## **Pedal Design Change**

## SC916 and SC5

This document explains the change that was made to the SC916 and SC5 model pedals.

Fig. 2

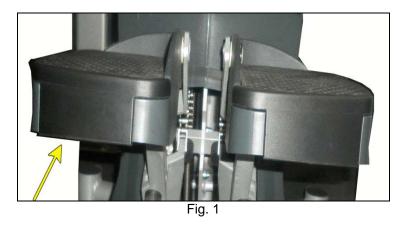
On the previous pedal design, there have been reports the flaps on the pedals were detaching or tearing from the upper portion of the pedal (Fig. 1 and Fig. 2).

StairMaster has made a design change to eliminate the previous issue. The newly designed part numbers are

- 055-0089, left pedal assembly
- 055-0093, right pedal assembly

The new design provides a secure pad with no additional rubber on the pedal (Fig. 2). As Fig. 3 and Fig. 4 show, there are no flaps of plastic between the top of the pad to the base of the pad.
